## 2.15 Structures and Servicing Systems

The information in this section of the reference ABWR DCD, including all subsections, tables, and figures, as modified by the STP Nuclear Operating Company Application to Amend the Design Certification rule for the U.S. Advanced Boiling Water Reactor (ABWR), "ABWR STP Aircraft Impact Assessment (AIA) Amendment Revision 3," dated September 23, 2010 is incorporated by reference with the following departures.

Table 2.15.5c Reactor Building Safety-Related Equipment HVAC System

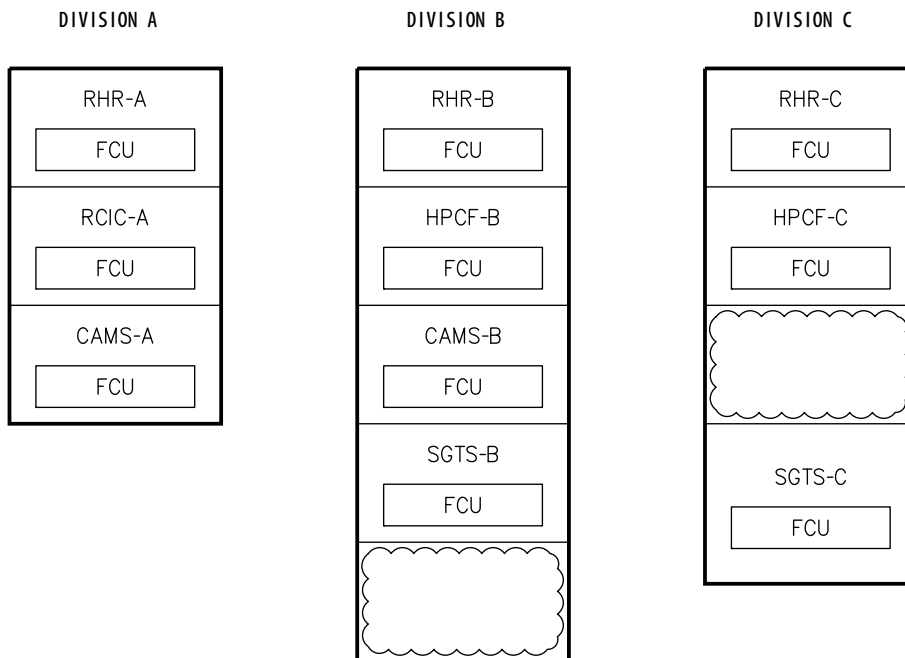
Inspections, Tests, Analyses and Acceptance Criteria		
Design Commitment	Inspections, Tests, Analyses	Acceptance Criteria
<del>4. The FCS room FCUs are initiated upon a manual FCS start signal. Not used.</del>	<del>4. Tests will be conducted on each as built FCS room FCU using a simulated initiation signal. Not used.</del>	<del>4. The FCS room FCU starts upon receipt of a signal indicating FCS start. Not used.</del>

**Figure 2.15.5e Reactor Building Safety-Related Equipment HVAC System**

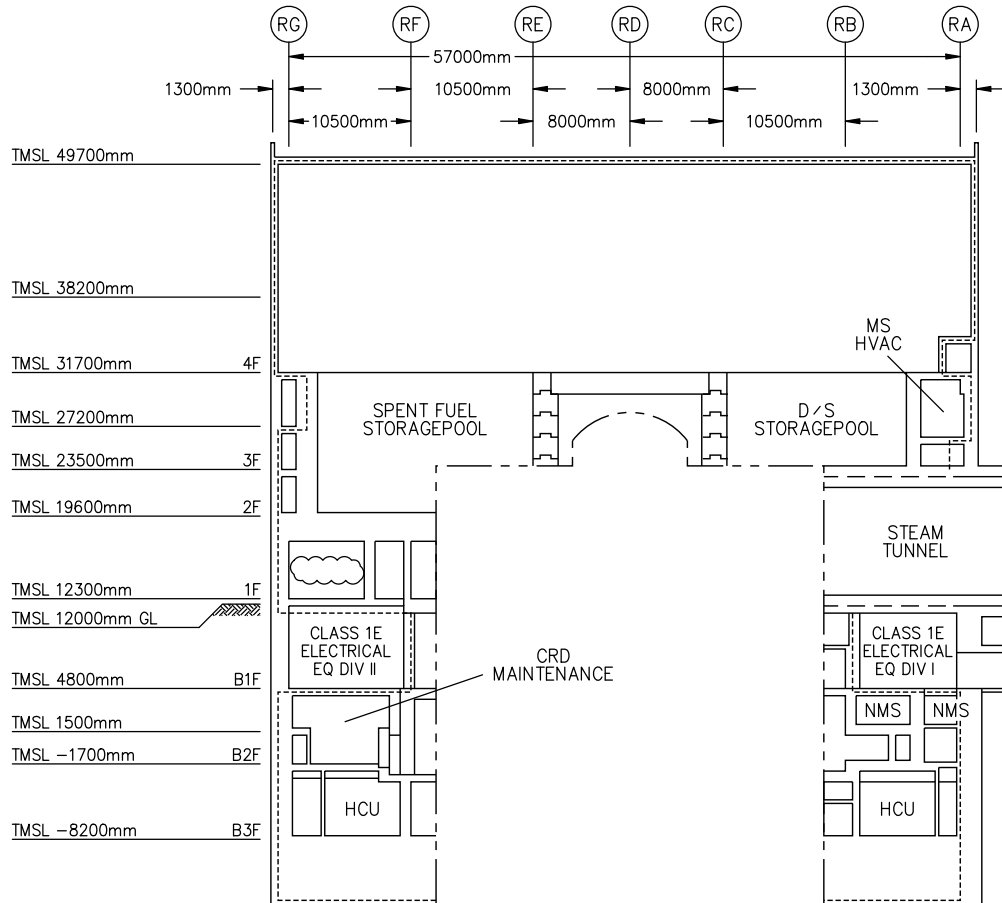
STD DEP T1 2.14-1 (Figure 2.15.10a, Figure 2.15.10j, Figure 2.15.5e, Table 2.15.5c)

*The R/B Safety-Related Equipment HVAC System provides cooling of safety-related equipment areas, and consists of independent fan coil units. Figure 2.15.5e shows the basic system configuration and scope.*

*The Residual Heat Removal (RHR) System, High Pressure Core Flooder (HPCF) System and Reactor Core Isolation Cooling (RCIC) System pump room FCUs are automatically initiated upon startup of their respective room process pump. The Containment Atmospheric Monitoring System (CAMS) and Standby Gas Treatment System (SGTS) room FCUs are automatically initiated upon isolation of the Reactor Building Secondary Containment HVAC System. ~~The Flammability Control System (FCS) room FCUs are also initiated upon a manual FCS start signal.~~*

Figure 2.15.12a Control Building Arrangement, Section A-A

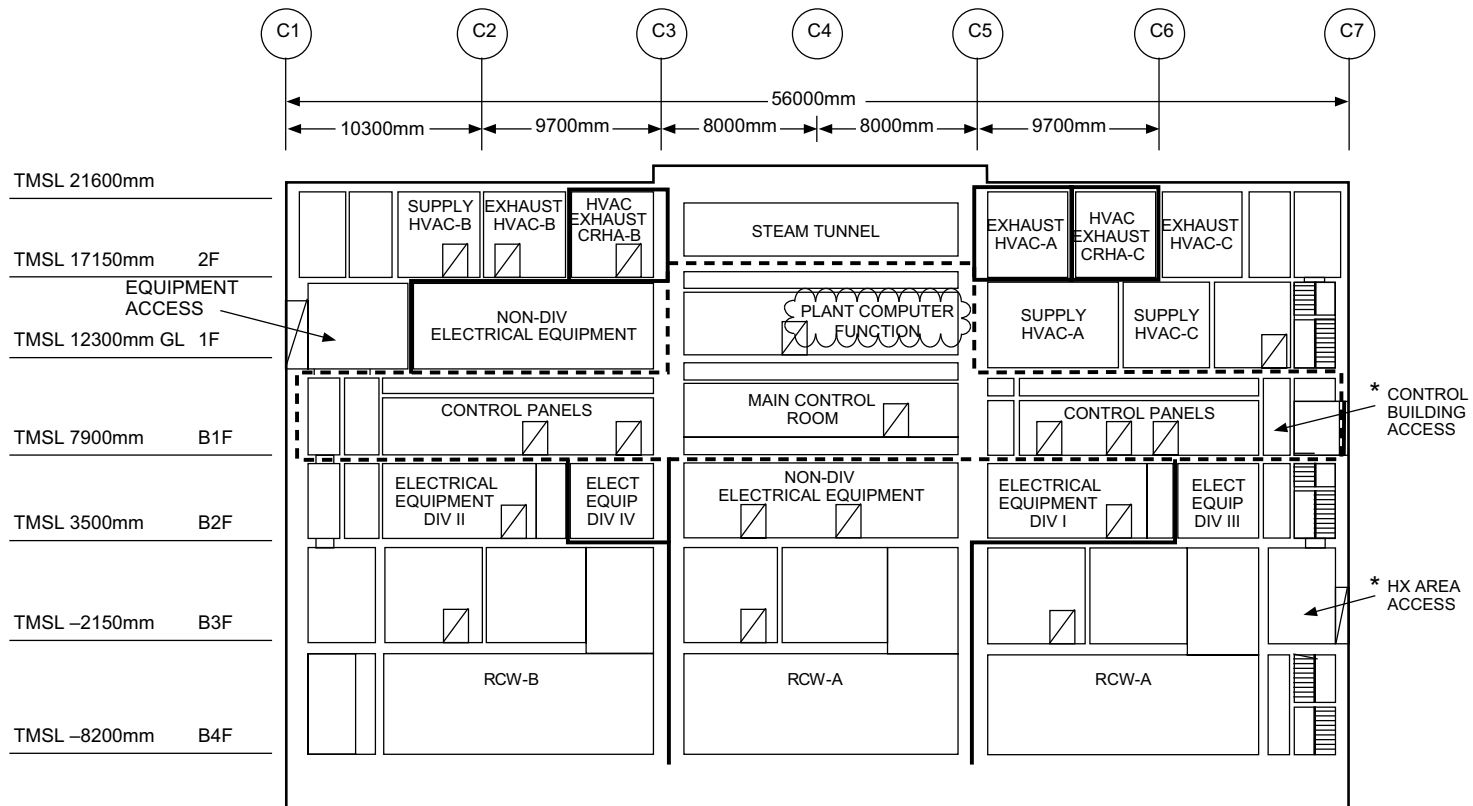
STD DEP T1 3.4-1 (Figure 2.15.12a, Figure 2.15.12b, Figure 2.15.12g)
